Access Compliance Report

Public Rights-of-Way

Intersection ID: 16373	Main Street: MONROE RD	Cross Street: EATON RD	Location: NE
ADA ID: 06D5F4ECECB3	Ramp Type: PerpDiag	Initial Pass/Fail: Fail	Overall Compliance: No
Severity Score: 37.5			
Codes/Mitigation Info/Possible Solution		Field Measurements/Component Compliance

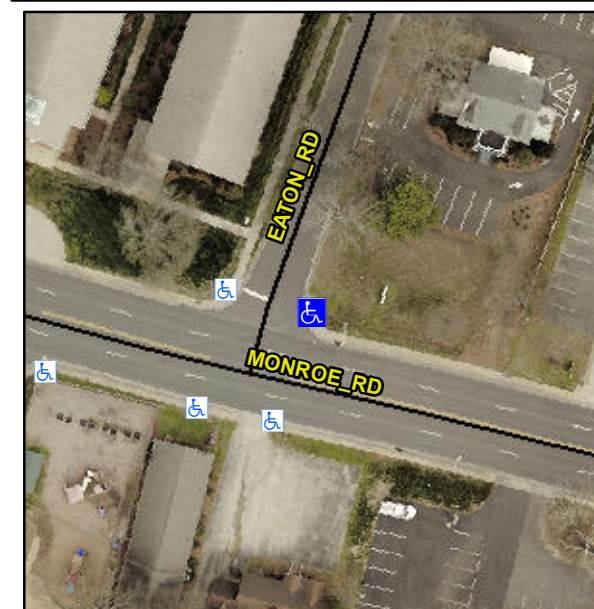
Not Found, R304.2.2, R304.5.3

Compliance	Description	Data	Compliance	Description	Data
N/A	Ramp Length (in)	49.0	No	Ramp Slope (%)	9.2
Yes	Ramp Width (in)	48.0	No	Ramp XSlope (%)	9.2
N/A	Flare Type LT	N/A	N/A	Flare Type RT	N/A
N/A	Flare Slope LT (%)	N/A	N/A	Flare Slope RT (%)	N/A
N/A	Flare Traversable LT?	N/A	N/A	Flare Traversable RT?	N/A
N/A	Landing Length (in)	N/A	N/A	DWS Provided?	N/A
N/A	Landing Width (in)	N/A	N/A	DWS Contrast?	N/A
N/A	Landing Slope (%)	N/A	N/A	DWS Length (in)	N/A
N/A	Landing X Slope (%)	N/A	N/A	DWS Full Width?	N/A
N/A	Landing Curb? (Y/N)	N/A	N/A	DWS Offset (in)	N/A
N/A	Shared Landing?	N/A			
N/A	Gutter Ponding?	N/A	N/A	Gutter Slope (%)	N/A
N/A	Gutter Lip Ht (in)	N/A	N/A	Gutter X Slope (%)	N/A
N/A	Painted X Walk1?	No	N/A	Painted X Walk2?	No
	X Walk 1 Direction	To NW		X Walk 2 Direction	To SW
N/A	X Walk 1 Width (in)	N/A	N/A	X Walk 2 Width (in)	N/A
	X Walk 1 Slope (%)	9.7		X Walk 2 Slope (%)	6.8
	X Walk 1 X Slope (%)	6.7		X Walk 2 X Slope (%)	2.3

Remove & Replace Curb Ramp With Two New Directional Ramps or Equivalent.
